### TechTip

### TechFact

## TechFact

## New Current Sensor

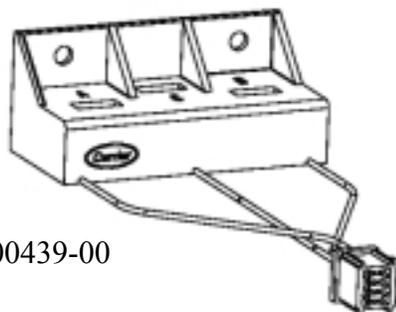
Starting at the beginning of this year, Carrier Transicold introduced a new current sensor,

P/N 10-00439-00 and 01 supersedes previously used current sensors, P/N 10-00366-xx.

The new sensor eliminates the push-on connections and comes with the MC plug already assembled as shown below.

If an old current sensor (10-00366-xx) is used as a replacement part for the new sensor, the push-on connections should be replaced with butt splices and heat shrunk afterwards.

P/N 10-00439-01

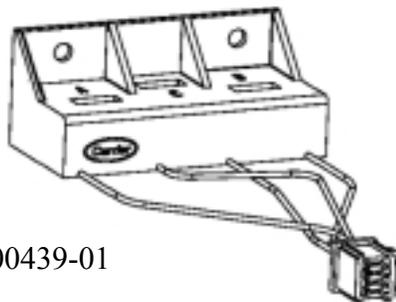
Eliminate
